**NOTICE OF A REGULAR MEETING
BONDURANT PLANNING AND ZONING COMMISSION
SEPTEMBER 8, 2022**

TITLE: -RESOLUTION NO. PZ-220908-25: Considering recommended approval of the site plan for the Midstates Precast Products parking lot and office project at 2340 Hubbell Avenue SW

TITLE: - RESOLUTION NO. PZ220908-26: Considering recommended approval of the Amazon Truck Wash site plan at 2300 Shiloh Rose Parkway SW

GRADING & UTILITY PLAN

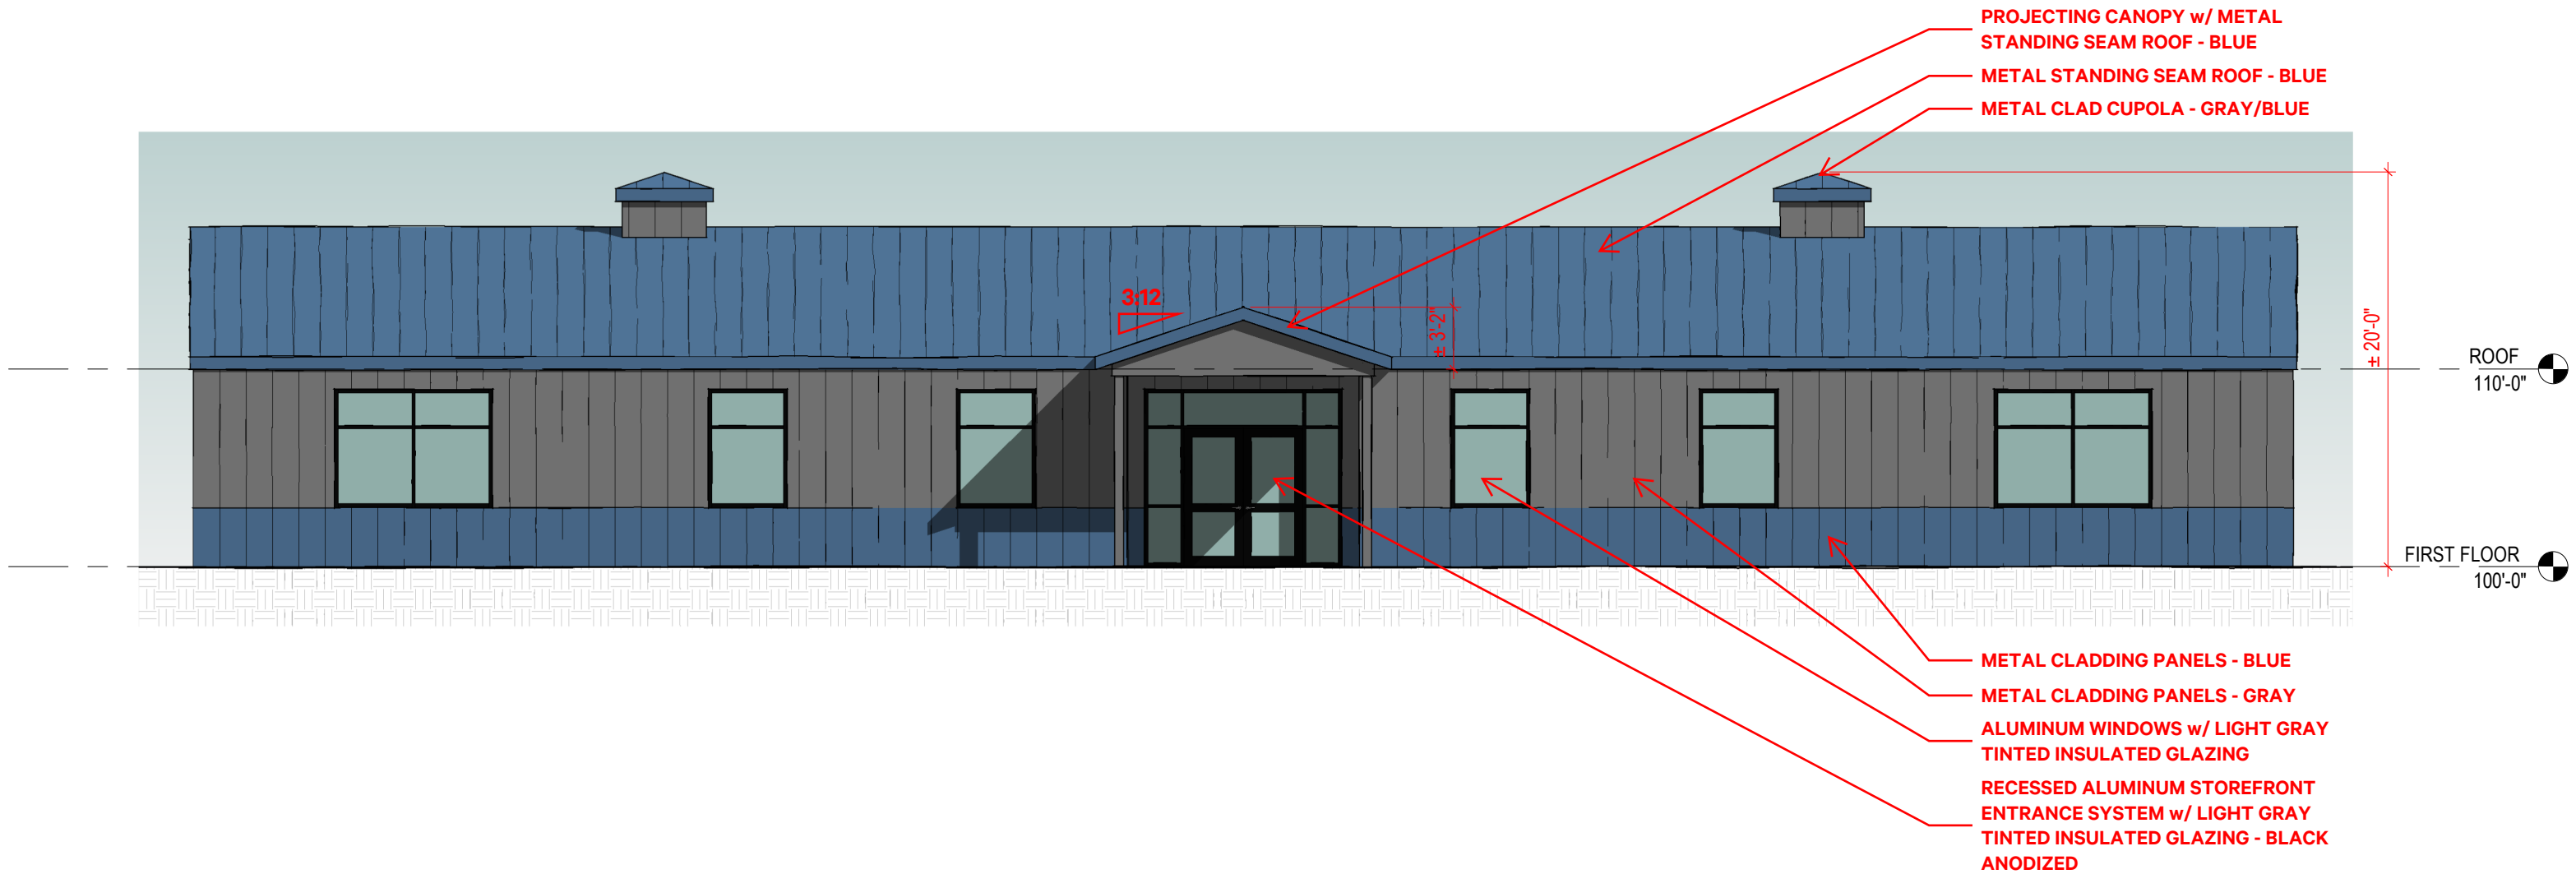
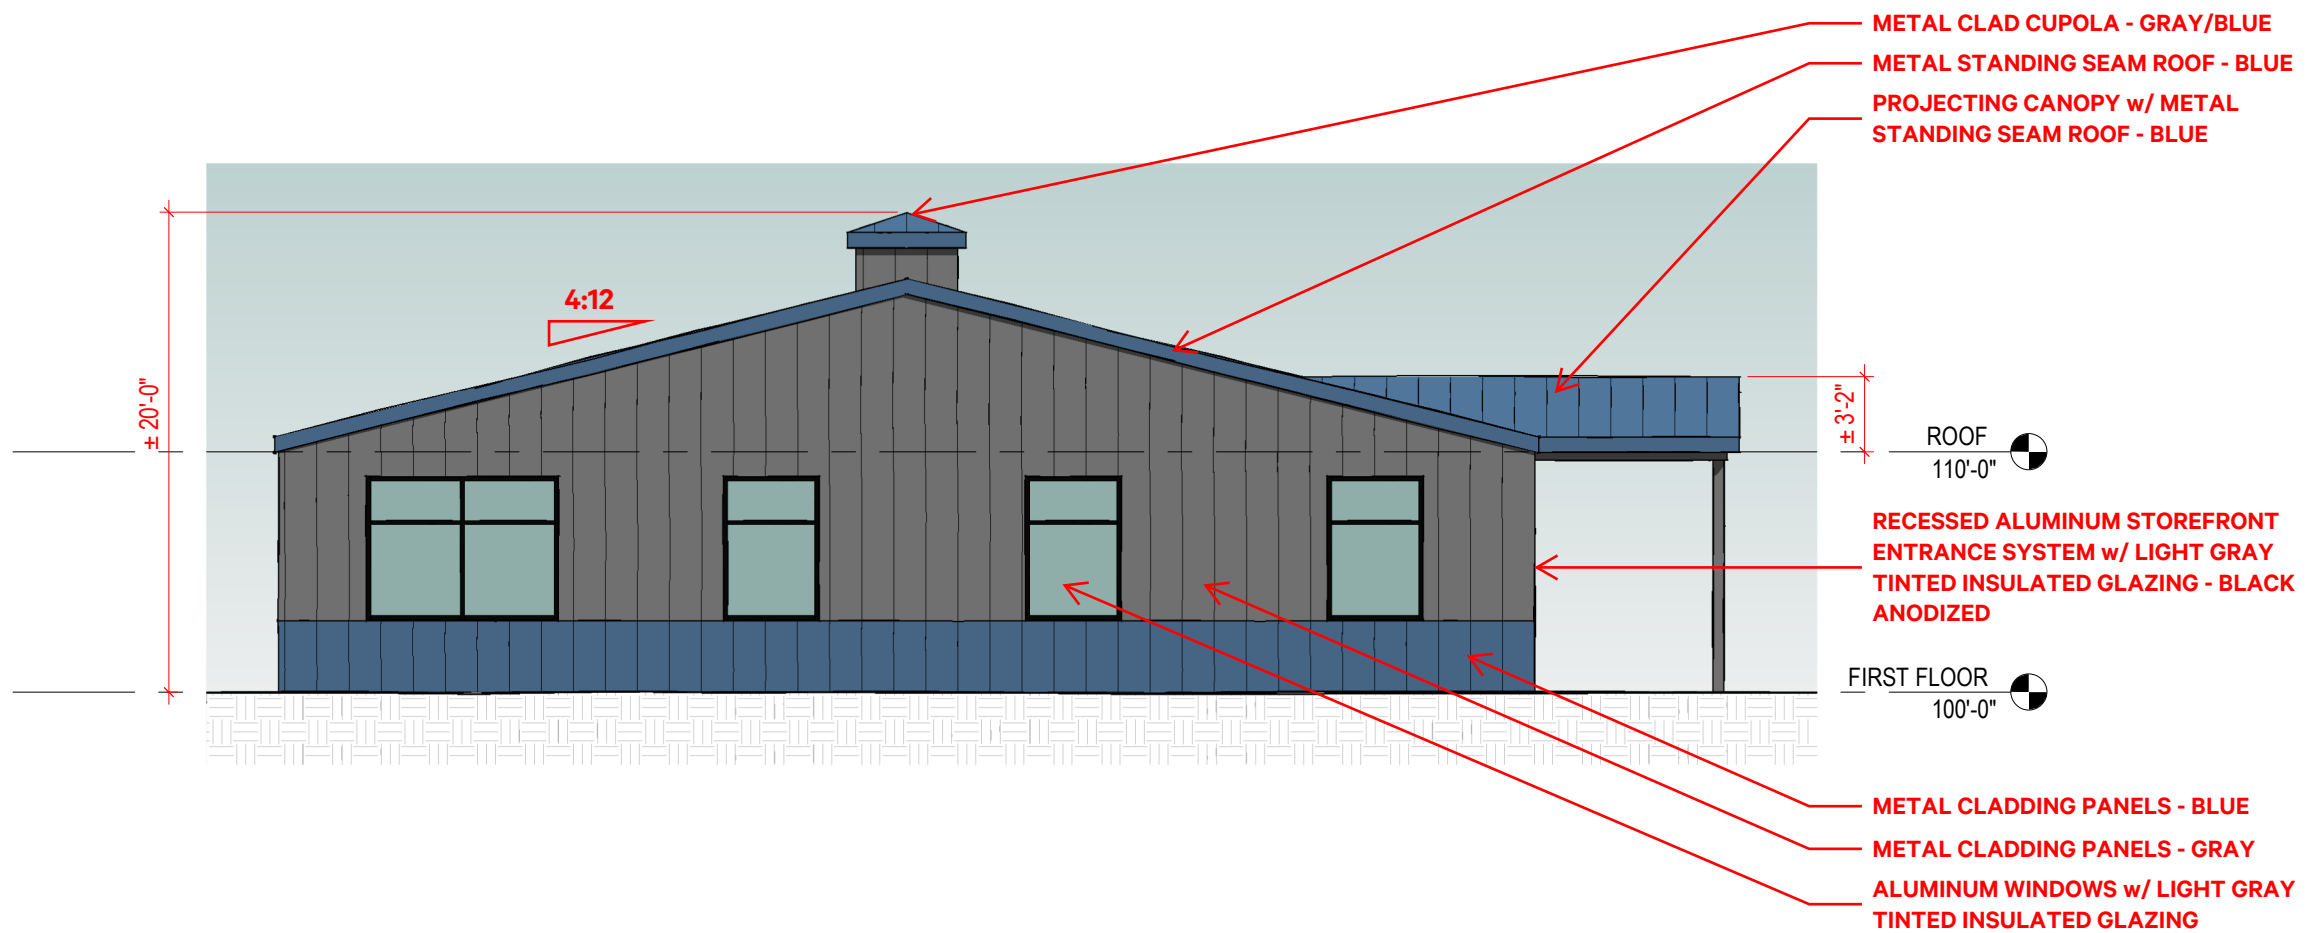
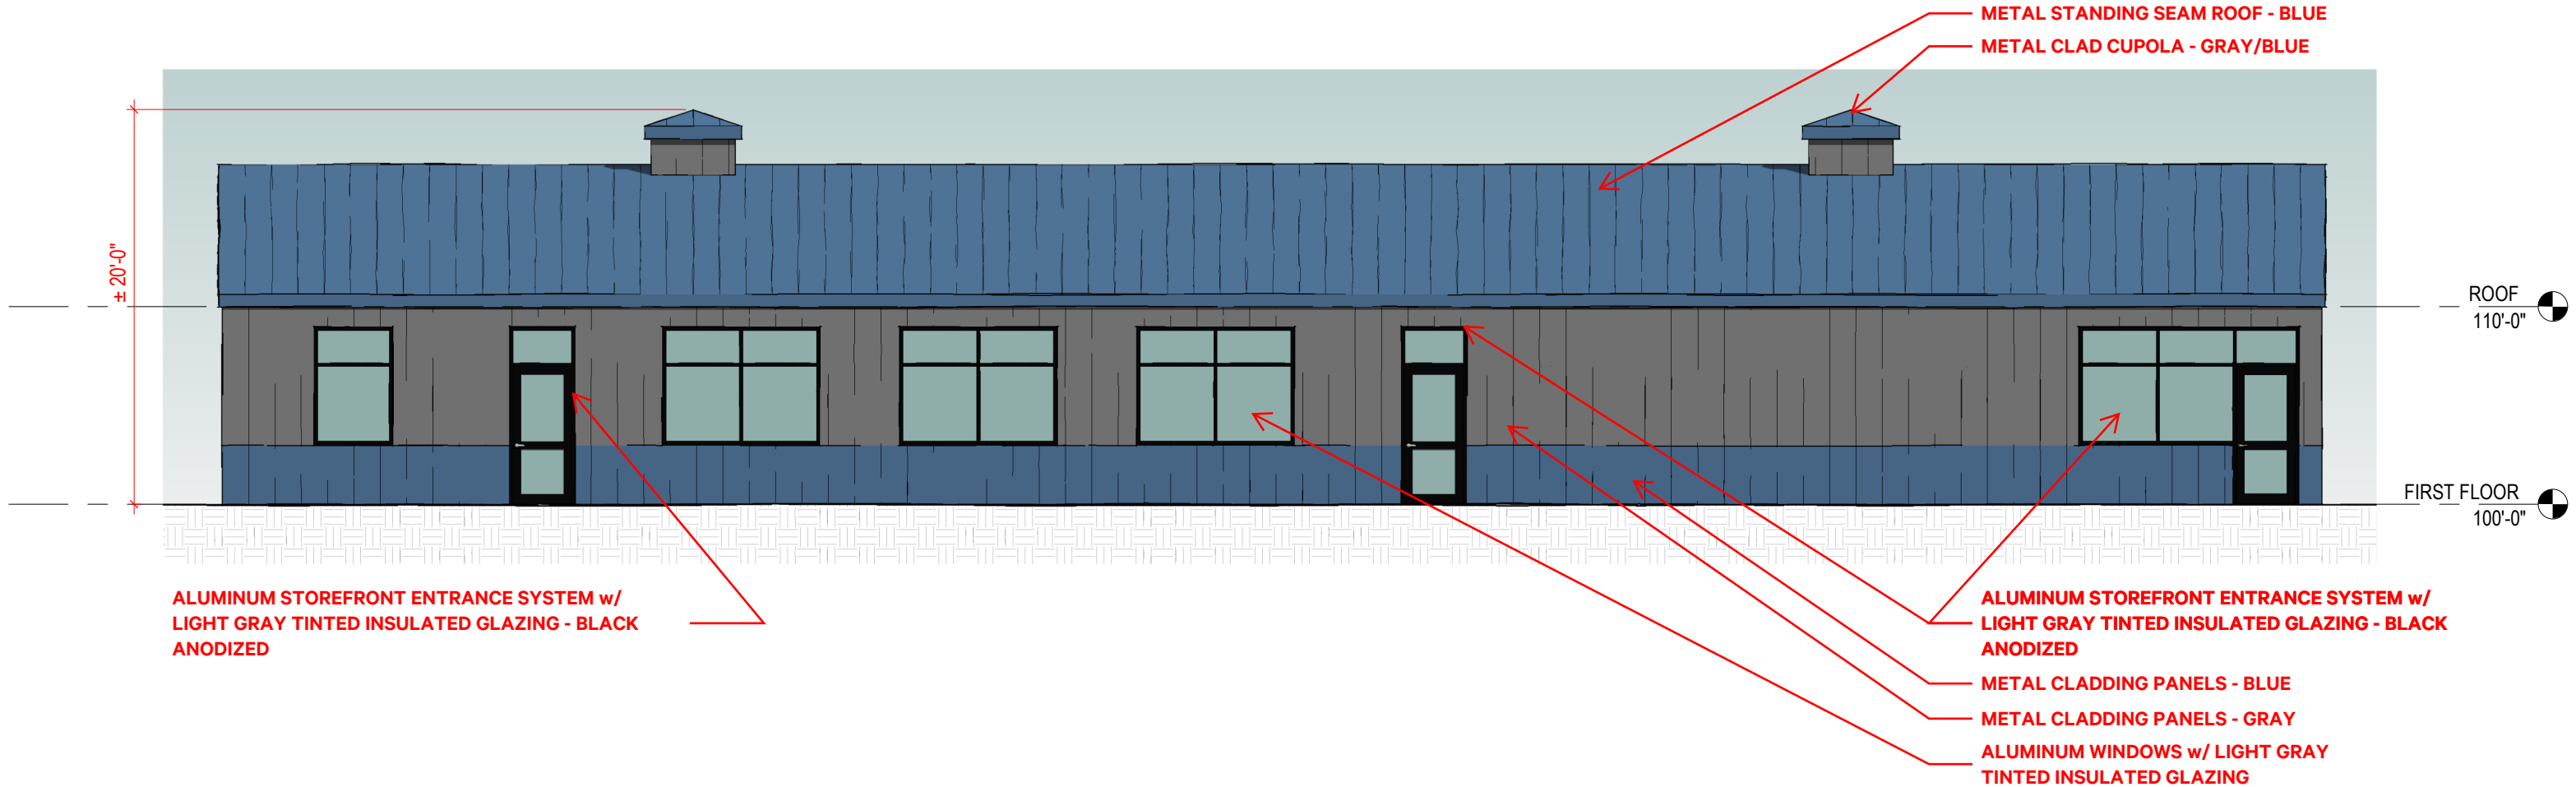
- Page 3 contains the required utility plan. Sanitary sewer, water, electric and gas are all being extended to the east side of the proposed building from existing utility lines.

- Site plan must be updated to include an interior greenspace percentage calculation to show that Section 177.10.7 of the Zoning Code is met. Section 177.10.7 requires that when a parking area is visible from a public street, the interior of such parking area shall be developed as follows: not less than 5% shall be landscaped and continuously maintained; planting along the perimeter of the parking area, whether required for screening or general beautification, will not be considered part of the 5% interior landscaping requirement.

2. That the site plan must be updated to show that interior tree and interior landscaping requirement are met.
3. That the building elevations must be updated to show the Overlay District building material requirements as being met, or that a variance by the Board of Adjustment must be obtained to allow for materials not meeting the Overlay District.

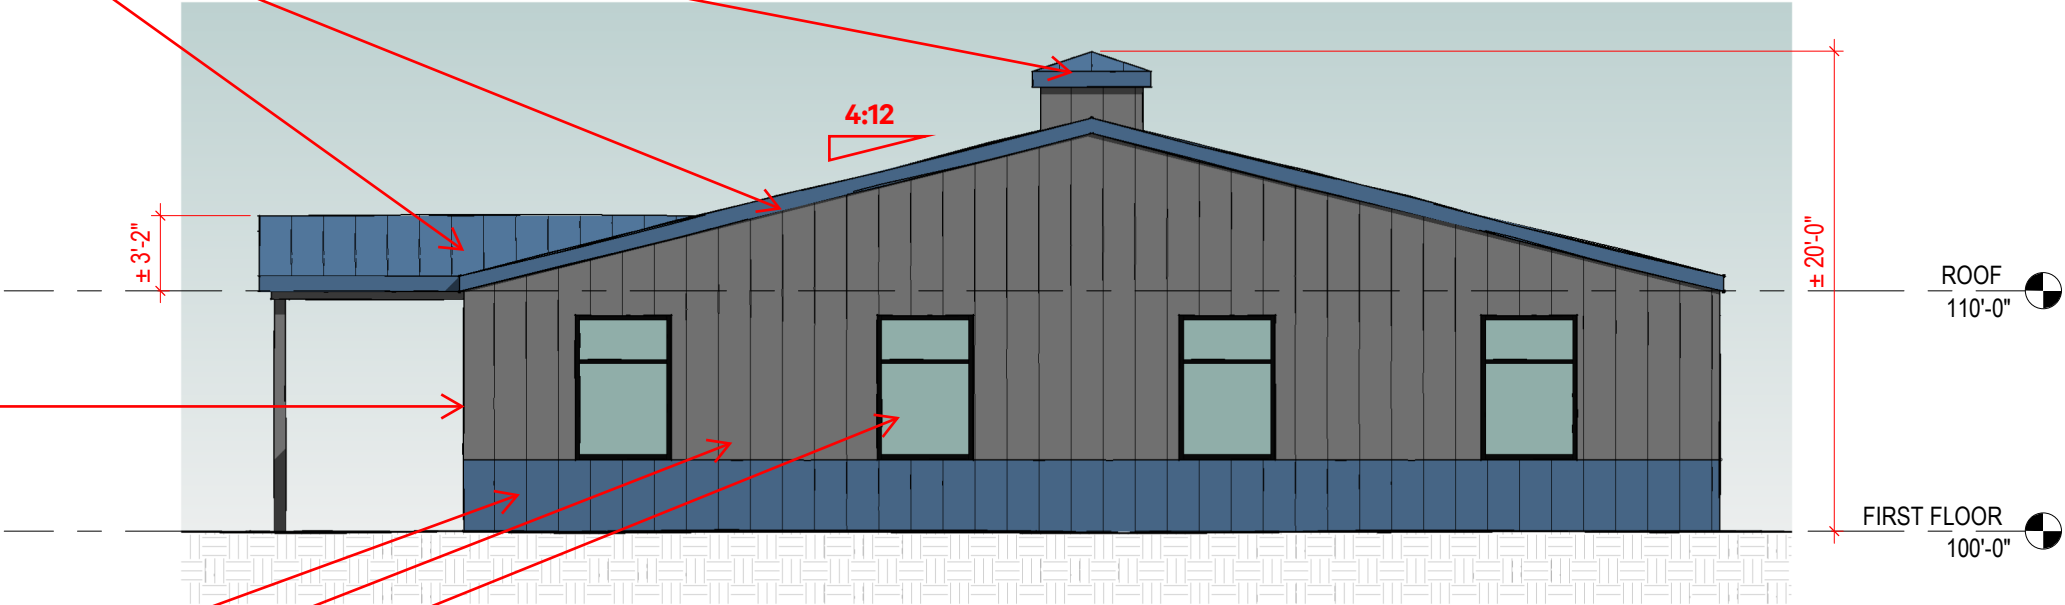
- Roof mounted mechanical units or other similar equipment shall be screened from public view by the extension of a parapet wall or other roof mounted equipment. Such screening shall have similar design features as the building including material, shape, and color considerations. *This item appears to be met, as the building elevations do not show any roof mechanicals.*

- Overlay Requirements (since the primary office use building falls within 500' of the Highway 65 right-of-way).
 - All buildings should be designed to minimize single-plane walls and boxy appearance through the use of pitched roofs, dormers, cupolas, multiple rooflines, and relief in long wall expanses. *This item is met through the use of pitched roofs, dormers, and relief in long wall expanses.*
